**NOTIFICATION OF ADDENDUM
ADDENDUM NO. THREE
DATED: May 2, 2022**

**Parmer Ranch Phases 9 & 10
City of Georgetown Williamson County, Texas**

Plan Revisions:

- Sheet 39 was Revised in this Addendum

Residential Streets (Typ.)

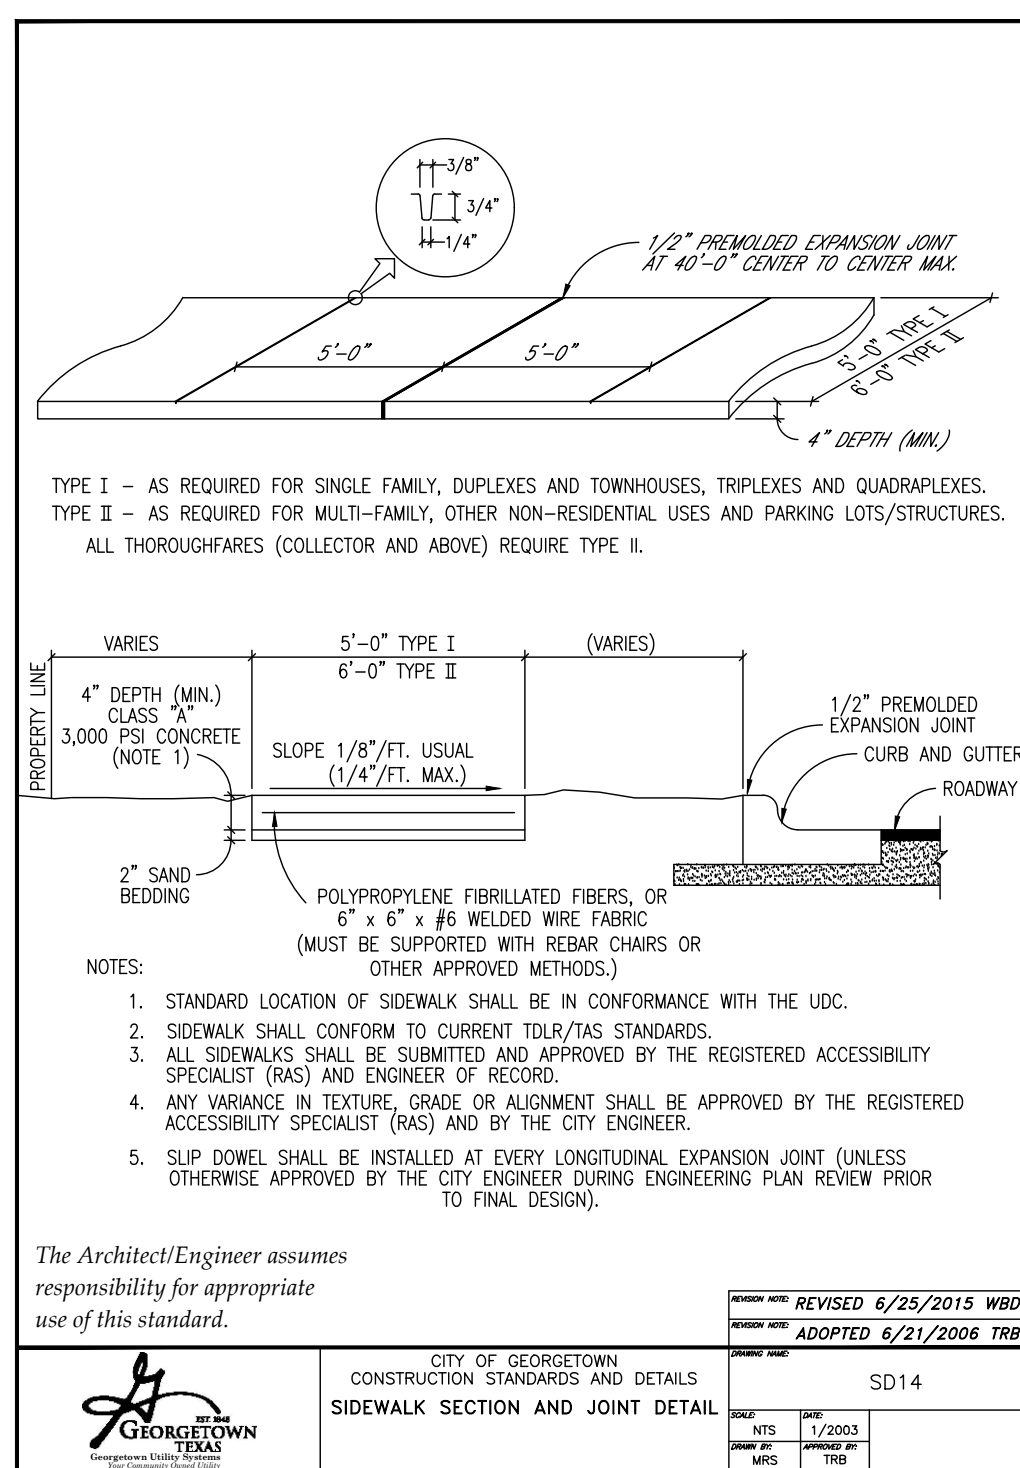
1. Will Street B have the same classification s the other streets considering it has a 65' ROW? If so, we are coming up with 1,144 SY of 10' Base for this street.
No, Street B will be classified as a Residential Collector (cross section has been added to sheet 39) with a 10" Flexible Base. Bid Item was updated on the bid form as well.
2. Will a bid item be added for the 6" PVC Line that leads to the tree well?
Bid form has been updated to include the 6" PVC line bid item.

NO.	REVISION	BY	DATE
2	ADDED STREET CROSS SECTION	TG	5/02/22
